Calaveras County Water District
Ebbetts Pass Water System
Reach 3A Pipeline Replacement Project

ADDENDUM No. 3

Date Issued: December 29, 2015

| APPROVED: CHARLES PALMER | DATE: DEC. 2015 | SHEET C-18 (STA 88+75/89+00) |

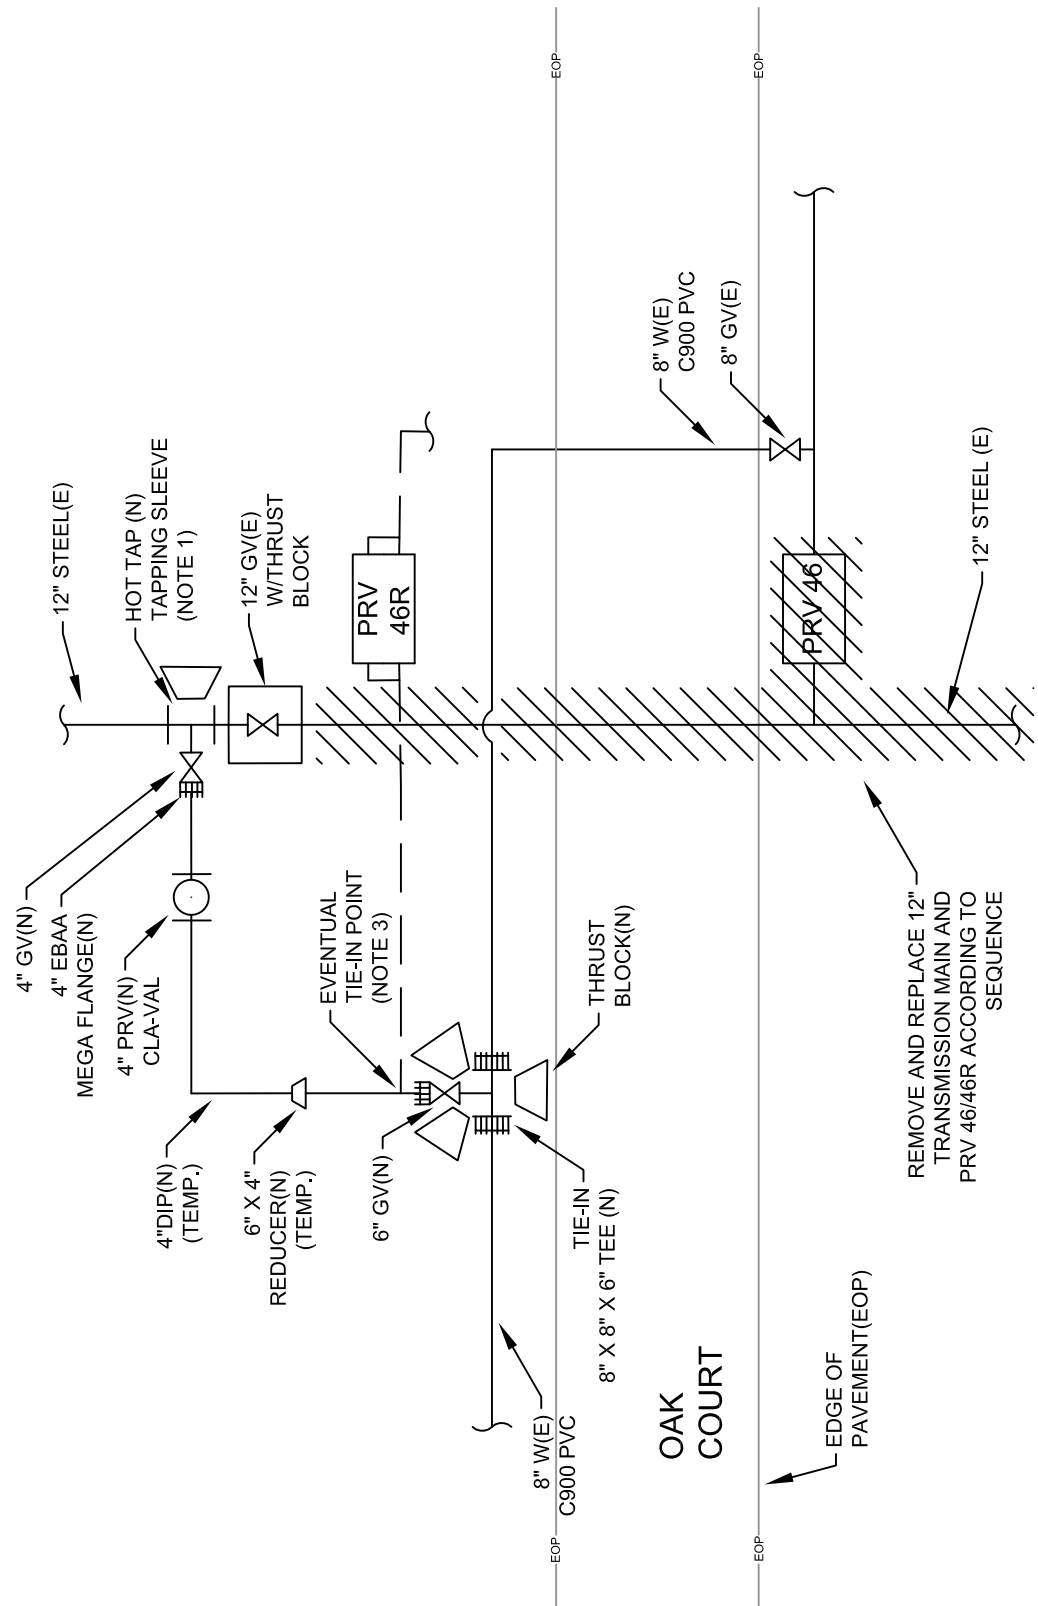
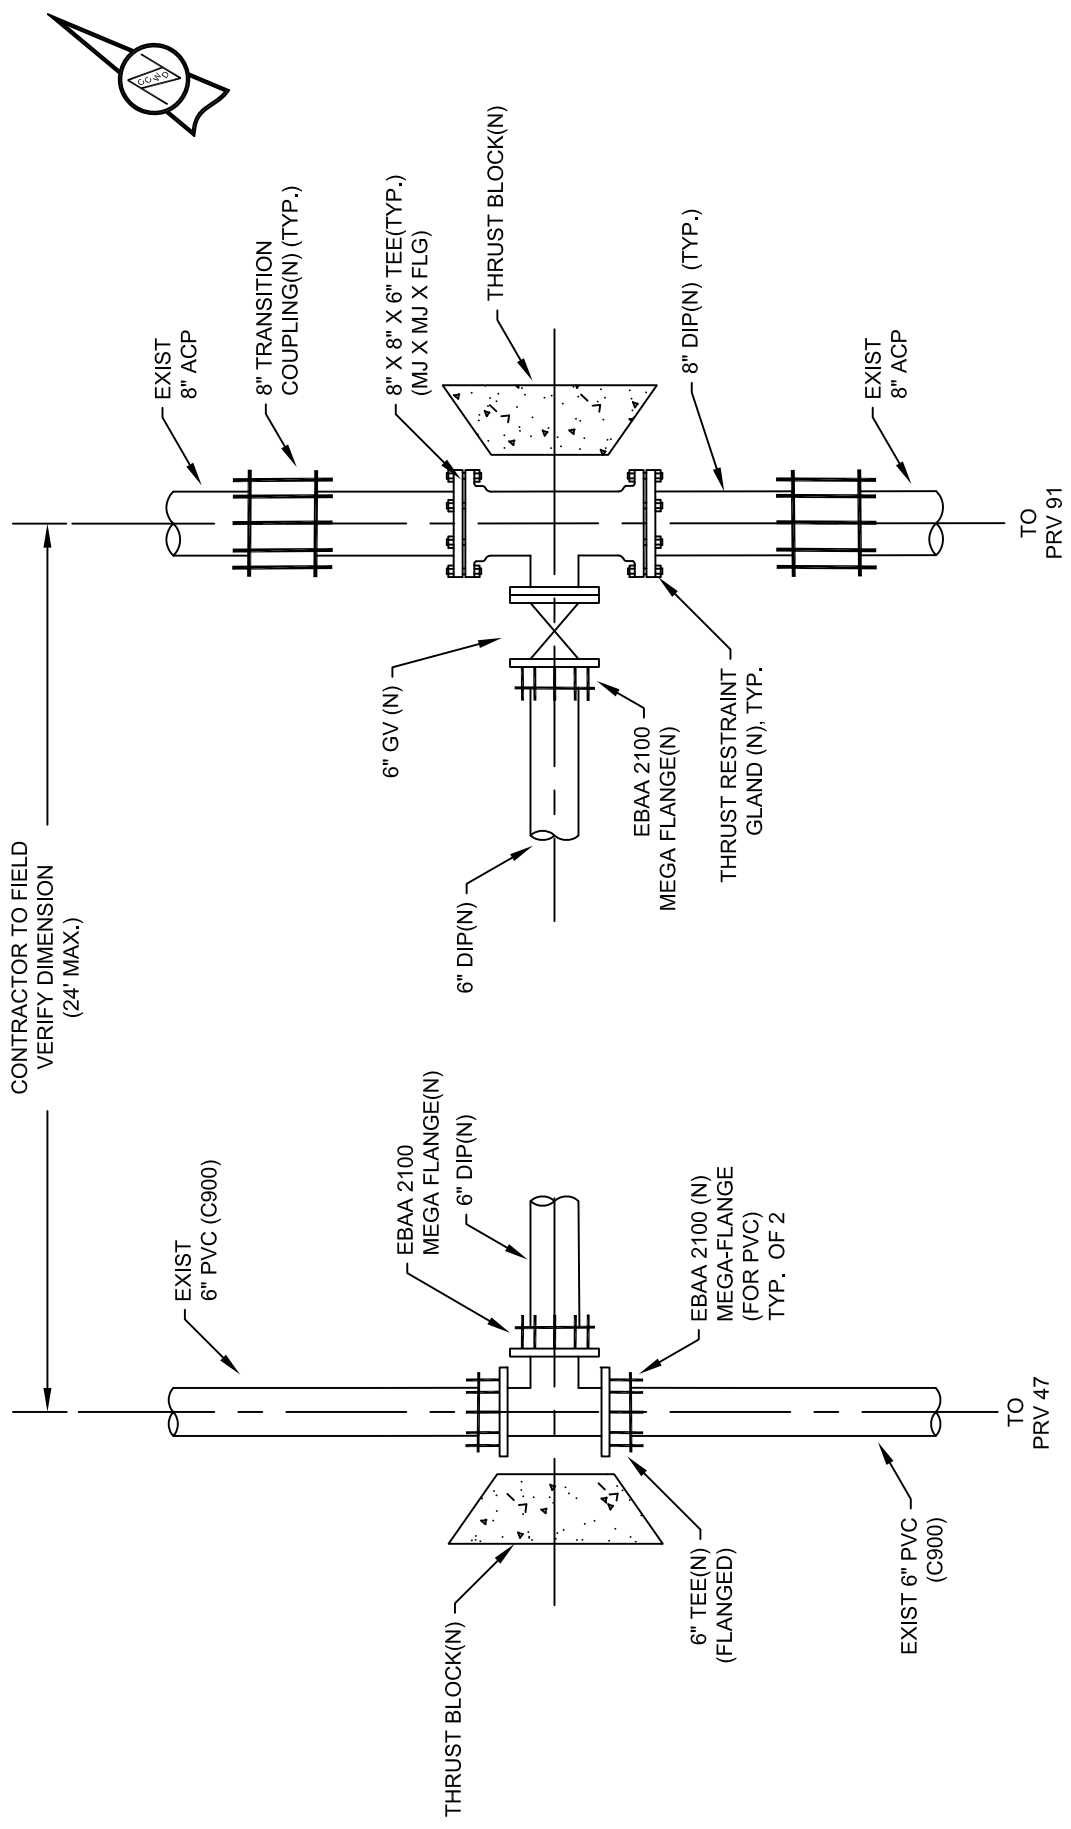
9. Drawing C-18 (Grid A3 & A4): On existing 12" steel main approximately STA 88+80, 50' Left (north), provide bypass with hot tap per attached Detail/PRV46 Temporary Bypass.

MANUEL RD. & FIR ST. TIE-IN DETAIL

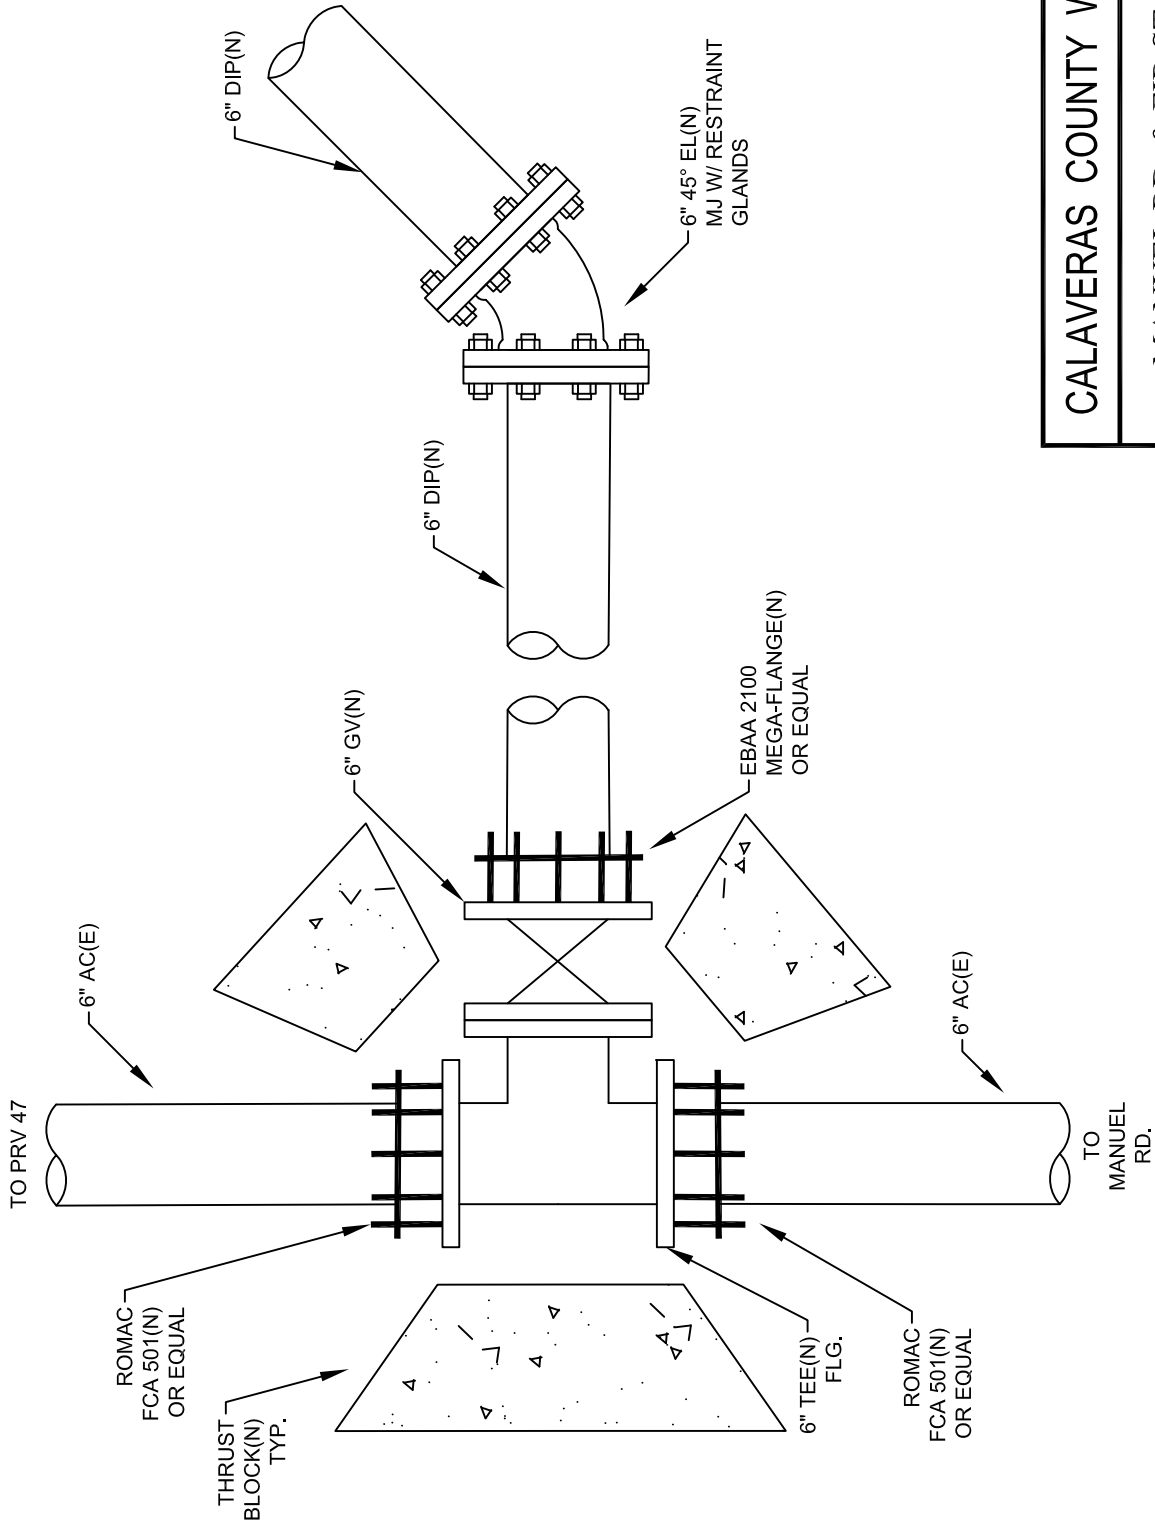
11. Drawing C-21 (Grid B4 & B5): For the new 6" water main serving the residential area along Fir St., add attached detail of tie-in connection at intersection of Fir St. and Manuel Rd.

| CCWD STAFF | NONE | SHEET C-26 |

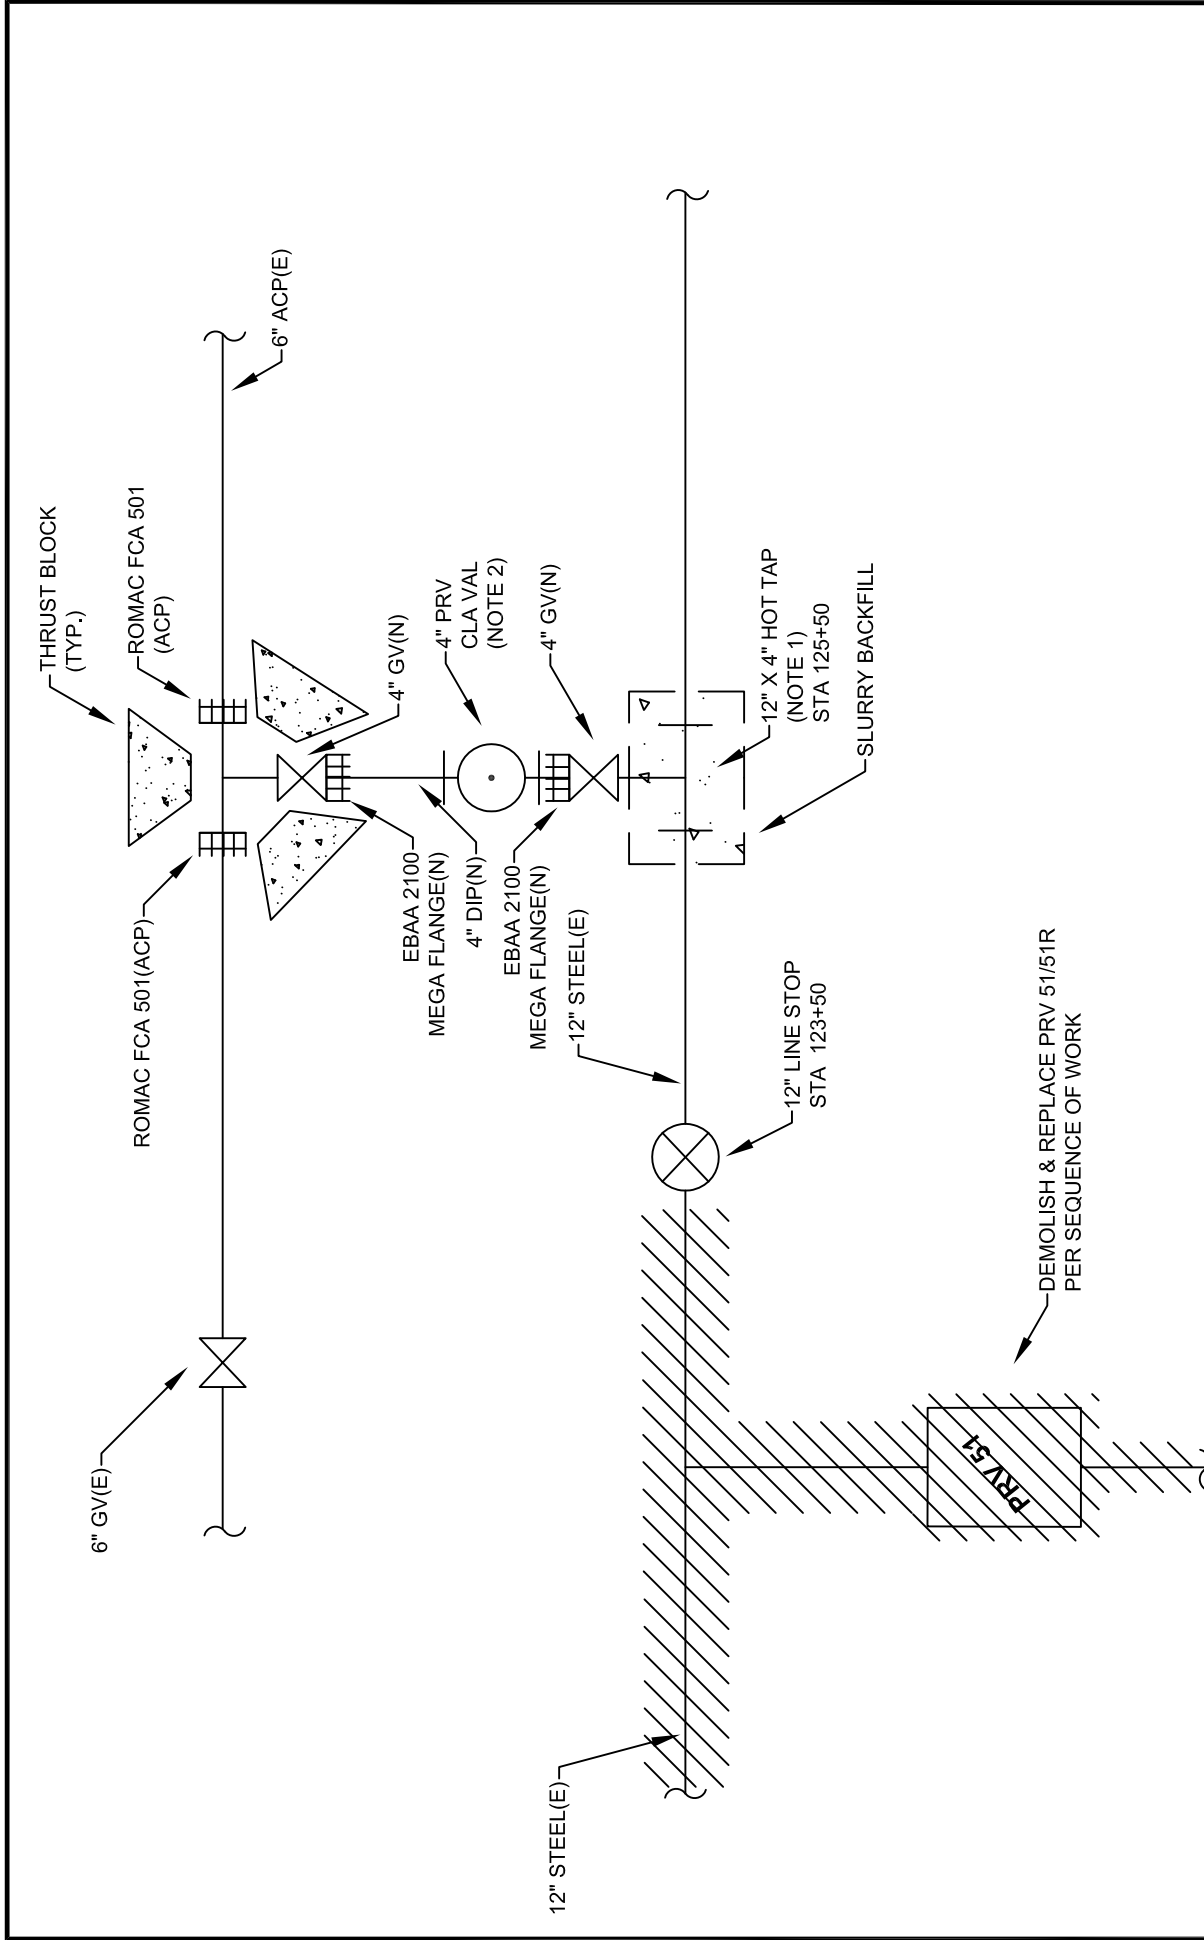
14. Drawing C-26 (Grid B2 & B4): On existing 12" steel main, add Line Stop at STA 123+50 and bypass/hot tap at STA 125+50 as shown attached Detail / PRV51 Temporary Bypass.

| DRAWN BY: CCWD STAFF | SCALE: NONE | CCWD DRAWING SHEET C-33 (STA 155+30) |

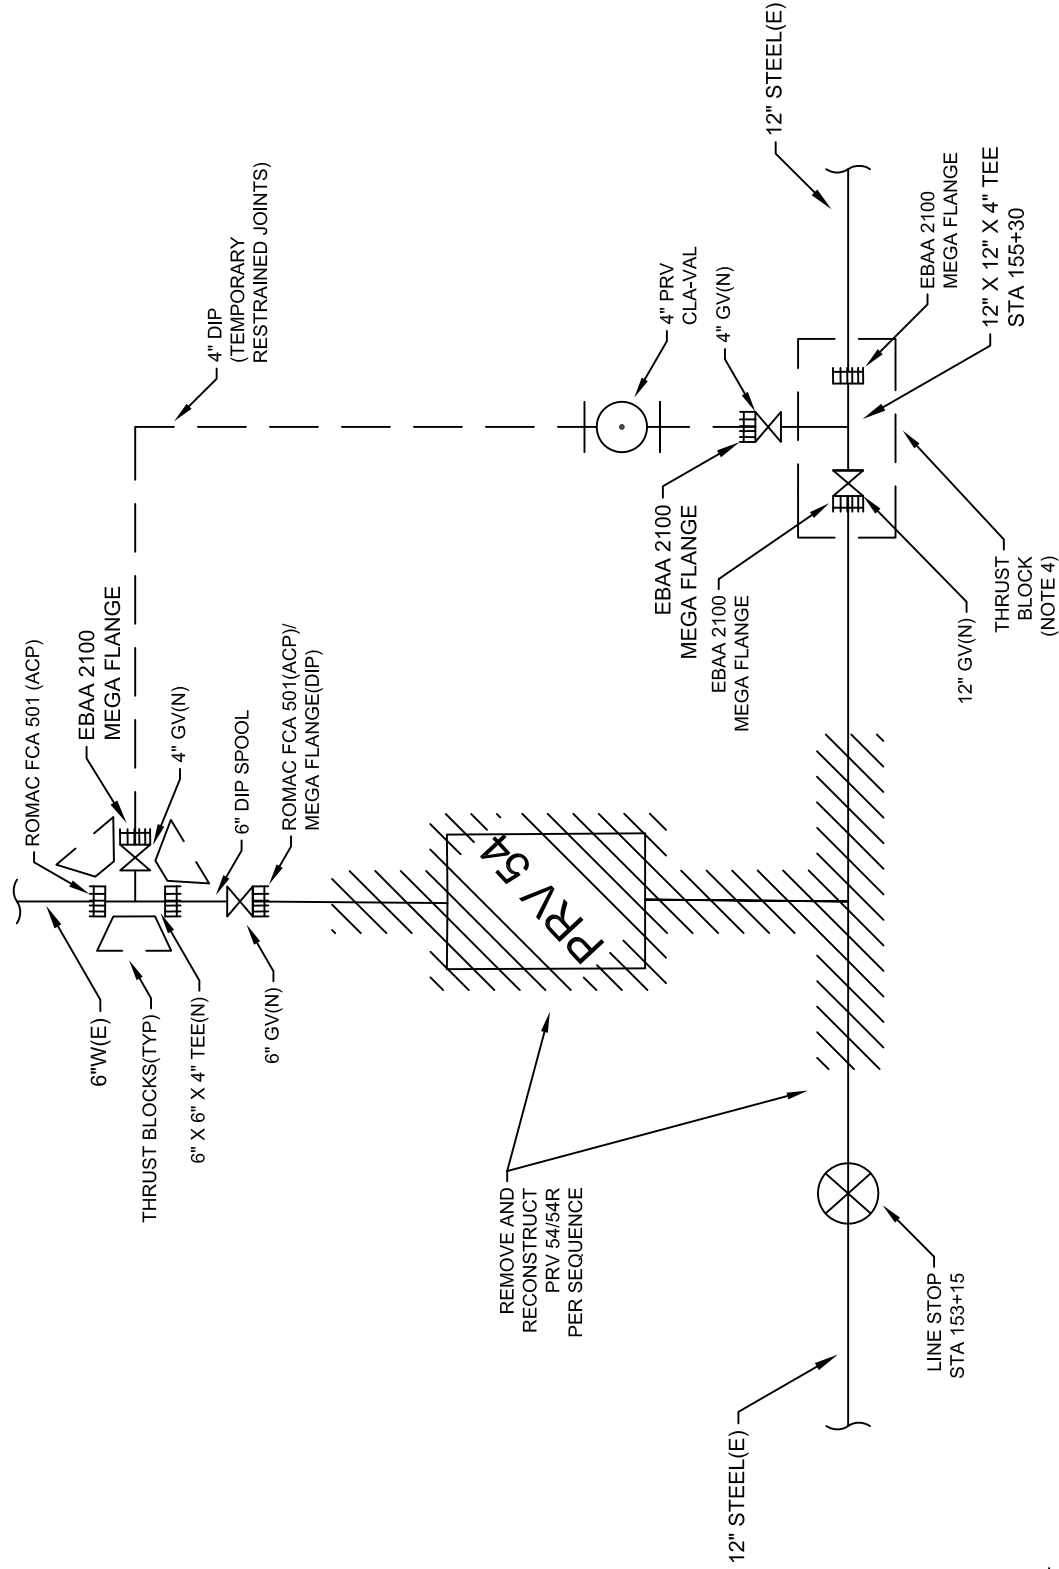
15. Drawing C-32 (Grid A4): Add Line Stop on existing 12" steel main at STA 153+15.
16. Drawing C-33 (Grid A2 & B2): On existing 12" steel main approximately STA 155+30, provide cut-in temporary bypass as shown on Detail / PRV54 Temporary Bypass.
